Service Bulletin

TM 306-31
TM 315-49
TM 320-6
TM 817-36

GROB

Subject: Inspection of the airbrake stops

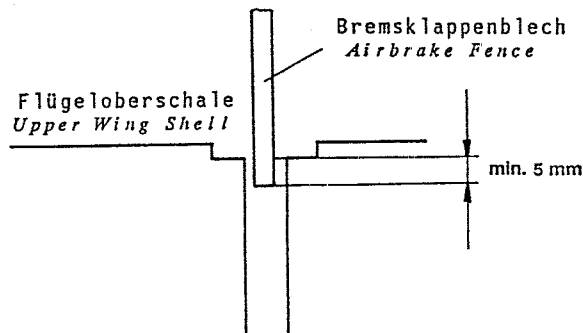
- Inspection of the airbrake stops**
As a precautionary action, the airbrake stops (outboard edge of the airbrake boxes) must be inspected for condition and wear. Cracks in the gelcoat around the outboard end of the airbrake box may indicate damage to the GRP laminate underneath. With the airbrakes fully extended wear to the airbrake stops must be checked; assure that the outer airbrake swivel levers are in contact with the stops during this check: The lower edge of the airbrake fence must overlap the bottom of the airbrake cap recess in the upper wing shell by 5 mm min. (see drawing below) Normal wear is acceptable as long as the upper condition is fulfilled.

If, during the inspection according to action 1, an excessive wear of these stops is found, a repair according to the Repair Instructions must be performed prior to the next take-off.
